Comments 254 Kansas
.com	Application No.: CPR-2019004211 Project Planner.: Ryan Loomis
	Notes
density is 30 du/acre with the 7 units. Per Basic Townsite lots over 10,000 SF are permitted Ind 24 du's per acre. (CD)	Lot Area: 9925 sf per Survey
includes a Design Review with Modification due or allowable density. This requires Planning ew. (CD)	Lot Area: 9925 sf per Survey
uture Design Review application provides items ecklist, including items requested below. (CD)	
provides legible dimensions, street names, alley, D)	
n items (doors, rooms, etc.) from the site plan.	
n the walls, utility boxes, etc. A six-foot high (6 ft.) decorative masonry, vinyl, wood, or opaque uired when abutting a single-family residential lot.	
of the building and all setbacks. Building is over	Bldg over parking deleted
information as far as # of units proposed, open	
row with actual and plan north. Ensure elevation ect direction. (CD)

Comments | 254 Kansas

DR-1.1

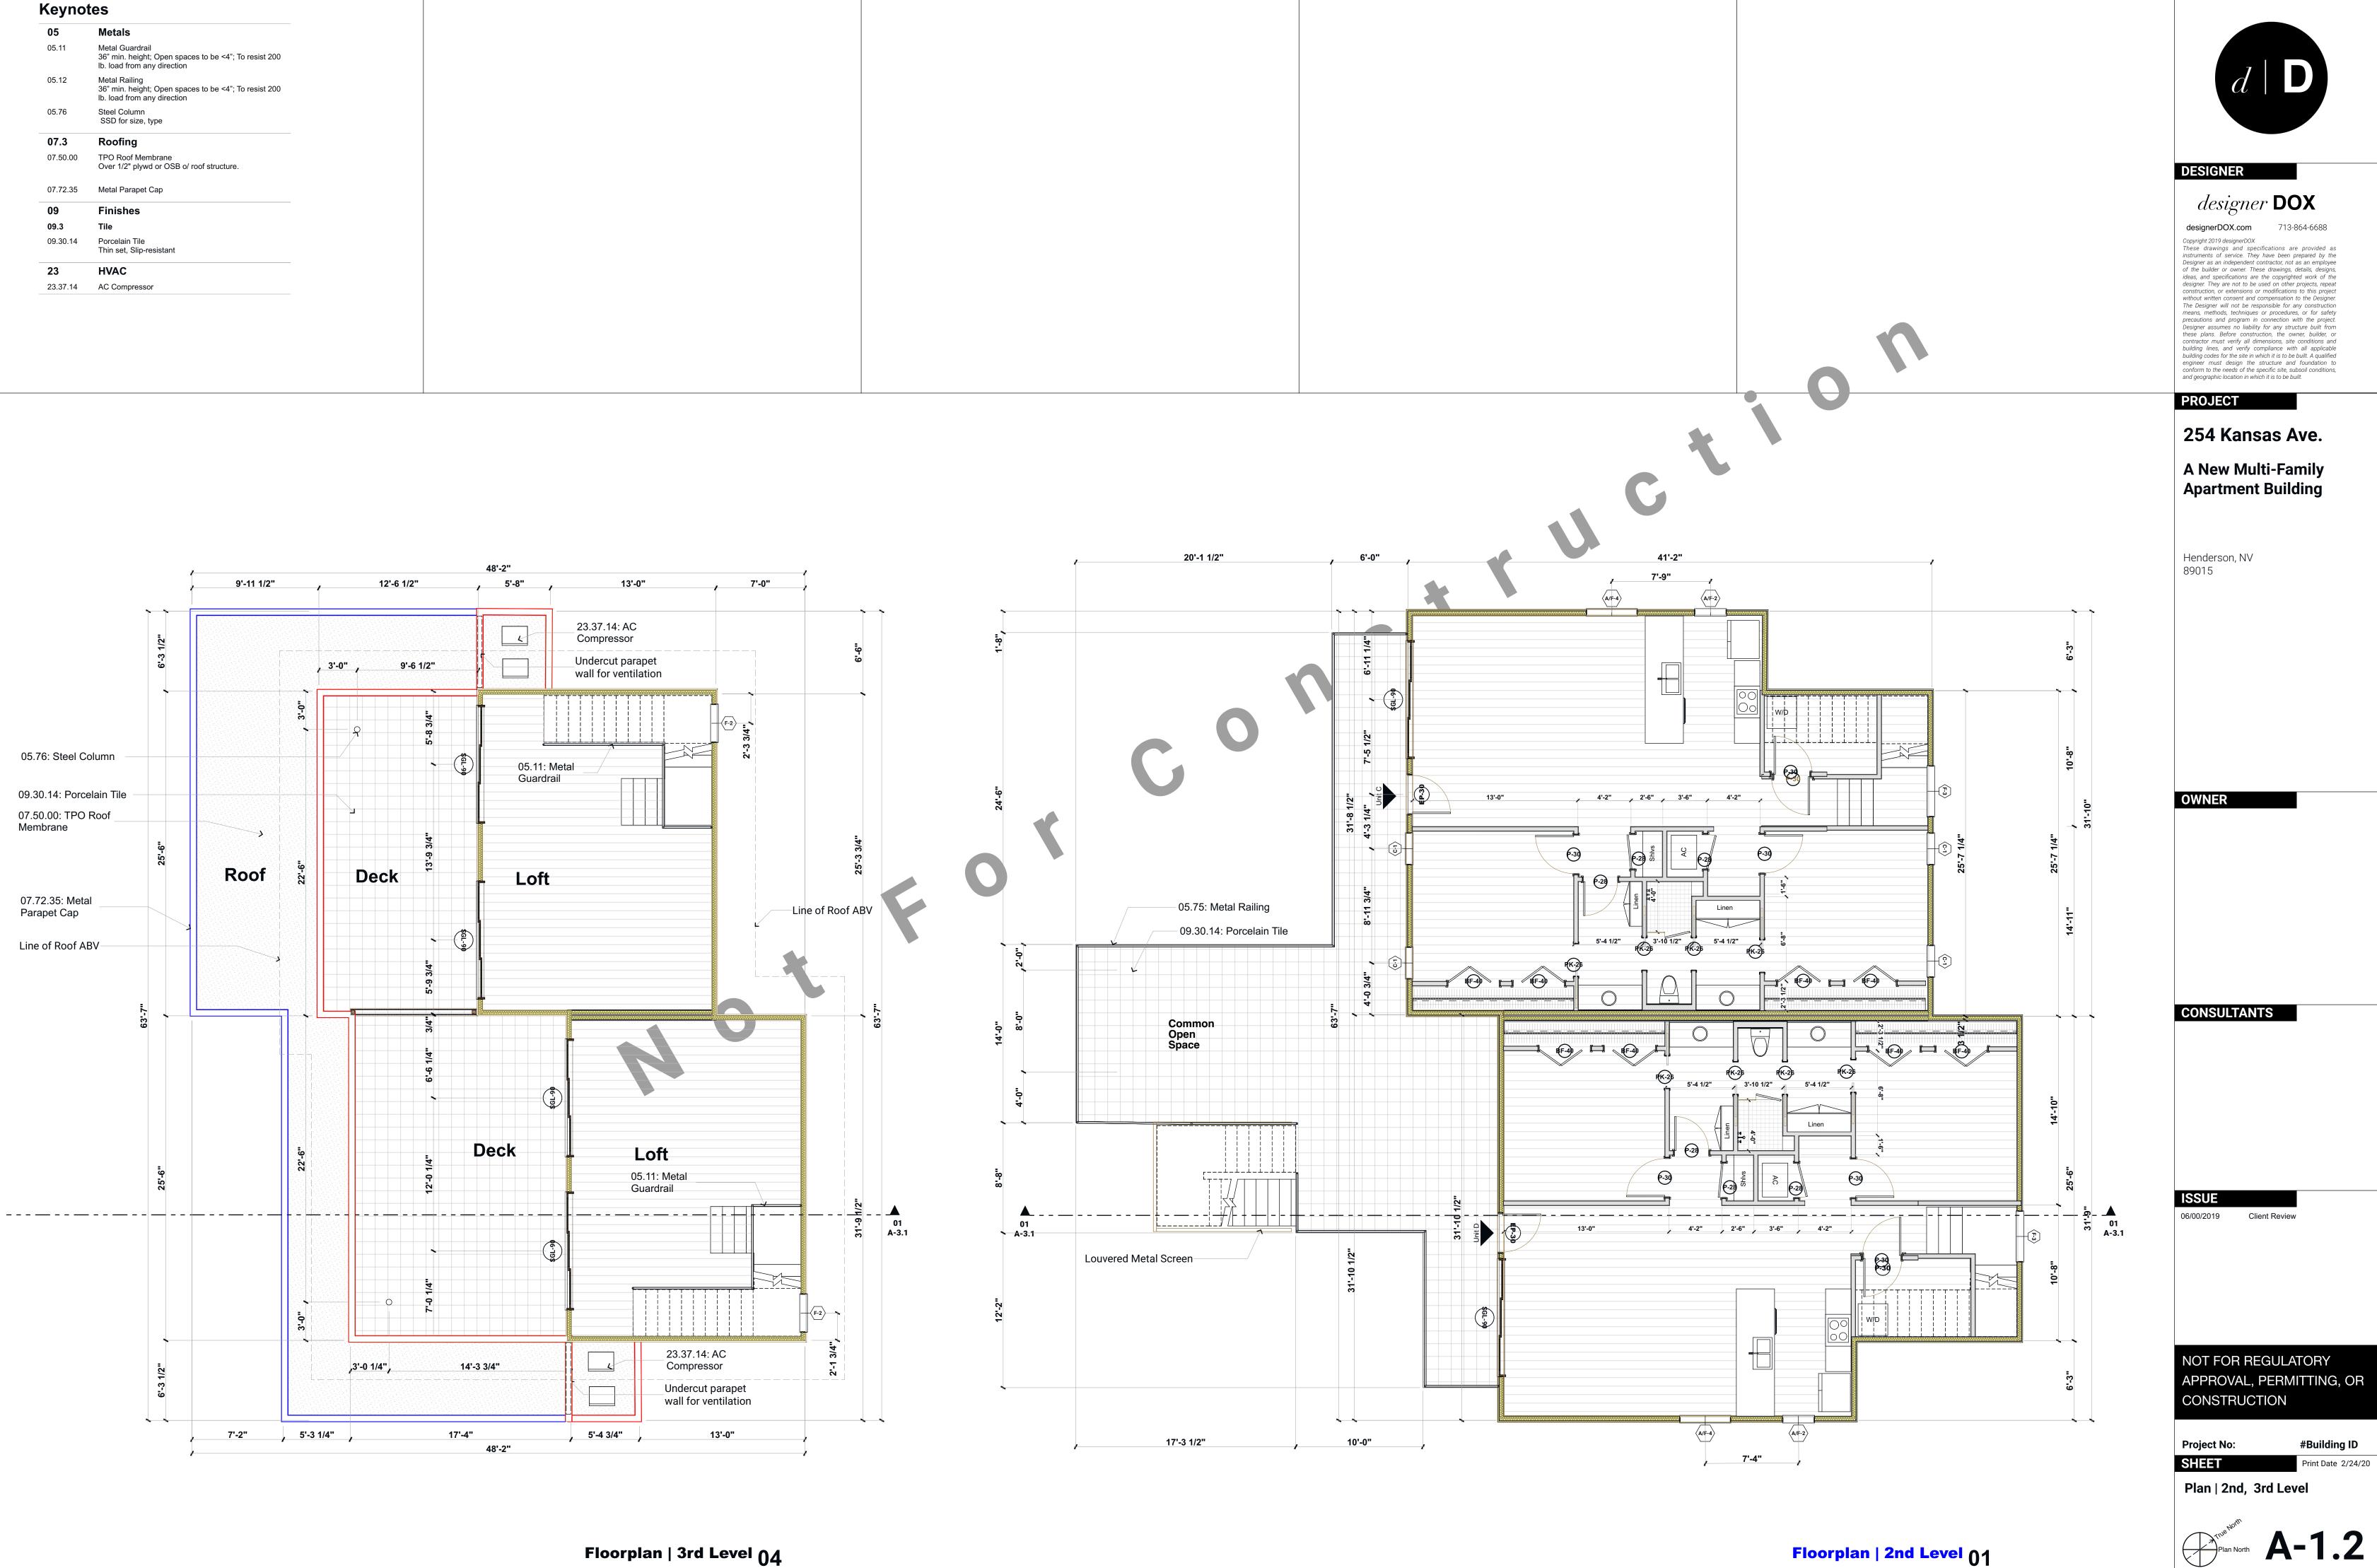
15.	A-1.3 Roof Plan	Please show location of HVAC. Provide screening p Screening. (CD)
16.	A-1.0 Site Plan	Please show amount of development is required t open space per residentia space not
